City of
Lawrence
Indiana

Address:	8101 Pendleton Pike (Valvoline Outlot)
Parcel #:	4013145
Docket #	26 LSV 07
Hearing Date:	05/19/2026
Council District #	1 ~ Tyrrell Giles

Request:
Variance of Development Standards of the City of Indianapolis Consolidated Zoning Subdivision Ordinances:

Site Plan:

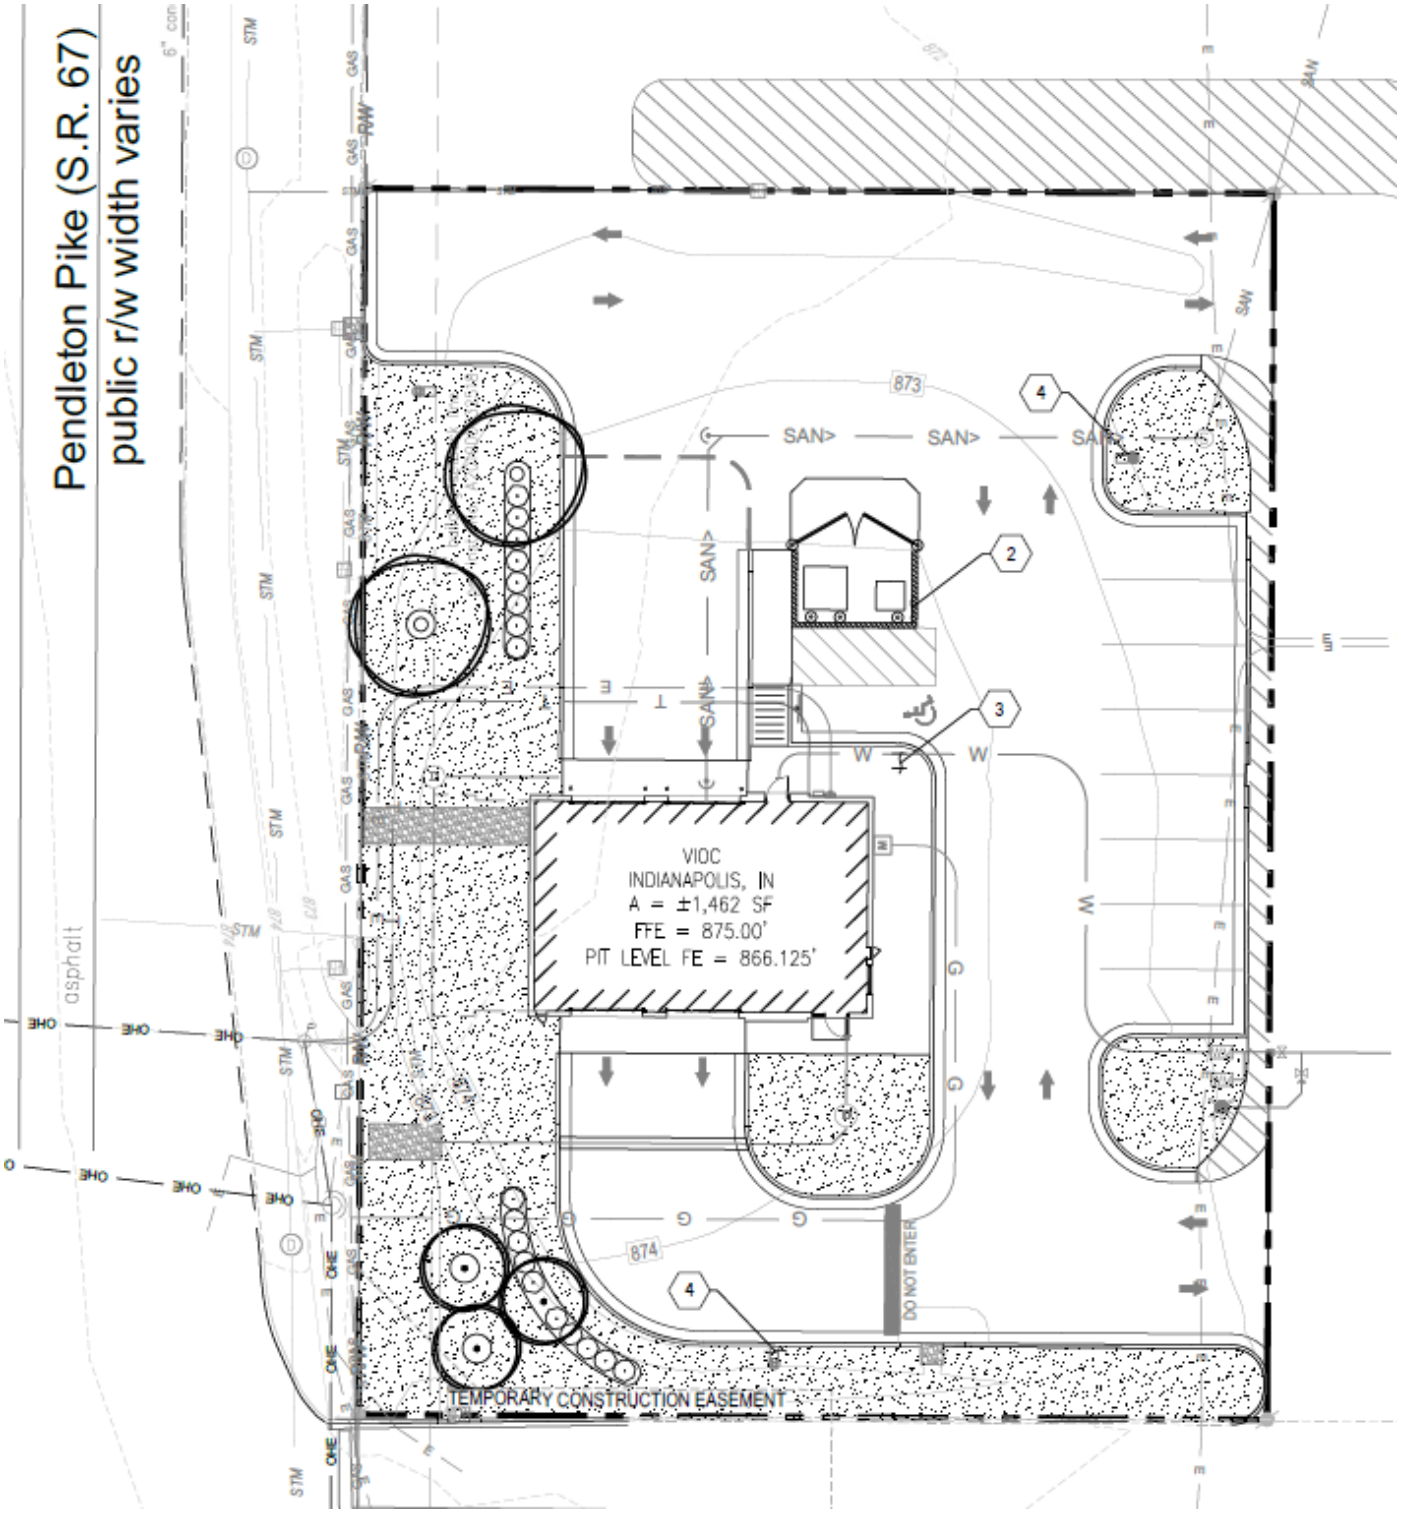
1. Sec 744-301-F ~ Internal Walkways
   Hard-surfaced walkways shall be provided in accordance with a pedestrian plan that shall include a walkway system that functionally connects all of the building's main front entrances with the sidewalk located in the public right-of-way of each of the freestanding lot or integrated center's eligible public streets. Revised plans showing compliance with this requirement are needed for review.

2. Sec 744-406-1 ~ Required Stacking Spaces
   Provide plans showing space for 2 cars before the oil change area and space for 2 cars after the oil change exit. These spaces should be 8.5’x17.5’.

3. Sec 744-406-1-C ~ Design and Location of Stacking Spaces
   In the Metro Context area, sites with stacking spaces shall include an exclusive bypass aisle, driveway or other circulation area in the parking lot design to allow vehicles to bypass the stacking area. The bypass aisle should be exclusive and run alongside the drive-through lane. It is meant to be an exit for cars once they are already in the stacking space area/drive through.

4. Sec 744-506 ~ Transitional Yard and Edge Buffering
   Where a commercial district, mixed-use district, hospital district, university quarter district, PK-II districts, or SU district for a public, institutional, or civic building or project abuts a dwelling district, a landscape buffer shall be provided

within the transitional yard. The D5 district across the street is a Protected District regardless of current use.

1. Internal Walkways (Sec. 744-301-F)
The requirement for internal pedestrian walkways ensures safe and functional pedestrian connectivity between buildings and adjacent public rights-of-way. The submitted plans do not demonstrate compliance, nor do they provide an alternative design that achieves the same intent.

The absence of pedestrian infrastructure is inconsistent with the goals of the Metro Context Area, which emphasizes walkability and multimodal access. Approval of this variance would undermine pedestrian safety and accessibility on the site.

2. Required Stacking Spaces (Sec. 744-406-1)
Stacking spaces are required to prevent vehicle queuing from extending into internal drives or public rights-of-way. The petitioner has not demonstrated that adequate stacking can be accommodated on-site.

Without sufficient stacking, there is a high likelihood that vehicles will queue into drive aisles creating congestion and potential safety hazards. This is particularly concerning given the high-traffic nature of the corridor.

3. Bypass Lane Requirement (Sec. 744-406-1-C)
The ordinance requires an exclusive bypass lane to allow vehicles to exit the stacking queue without obstruction. The submitted plans do not include such a feature.

The lack of a bypass lane reduces site functionality, increases the risk of internal traffic conflicts, and limits emergency access. This requirement is particularly important for drive-through style uses, such as the proposed oil change facility.

4. Transitional Yard / Buffering (Sec. 744-506)
The ordinance requires buffering when commercial uses abut protected districts. Although the D5 district is located across Pendleton Pike, and the property is being used commercially at this time, it is still considered a protected district under the ordinance.

The petitioner has not provided the required landscape buffer or justification for its omission. The absence of buffering fails to mitigate the visual and operational impacts of the proposed commercial use on nearby residentially zoned properties.
